UNITED STATES PATENT AND TRADEMARK OFFICE

APPLICATION NO.	FILING DATE	FIRST NAMED INVENTOR	ATTORNEY DOCKET NO.	CONFIRMATION NO.
09/902,310	07/10/2001	David W. Albrecht	SJO920010016US1	8192
28722	7590	04/01/2004	EXAMINER	
BRACEWELL & PATTERSON, L.L.P.			AGUIRRECHEA, JAYDI A	
P.O. BOX 969			ART UNIT	
AUSTIN, TX 78767-0969			PAPER NUMBER	
			2834

Office Action Summary

DETAILED ACTION

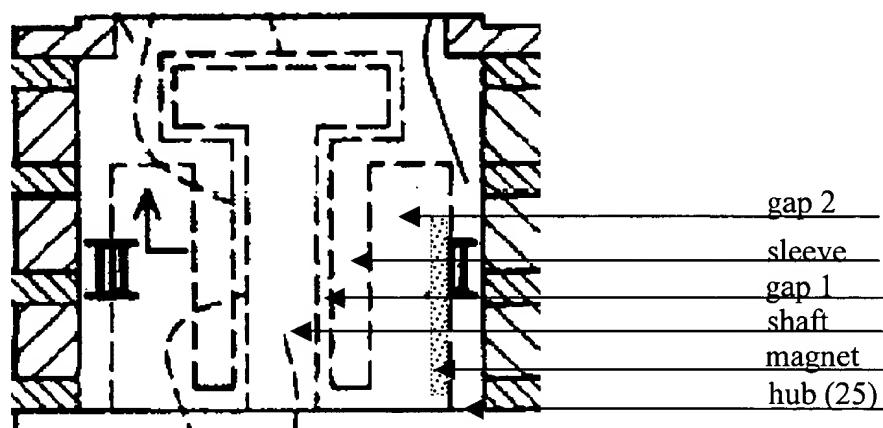
14. Applicants argument that there is only one gap disclosed in patent '366, the Examiner disagrees. In figure 2, Ichiyama shows a first gap between the shaft and the sleeve and a second gap between the sleeve and the hub. Applicants argument that the microgap exists between the shaft and the magnet, the Examiner disagrees. The magnets are located inside member 25, as Applicants acknowledge, but this does not mean that the gap is between the magnets and the shaft, but rather inside the member 25. As shown below, there is a gap between the sleeve and the hub.
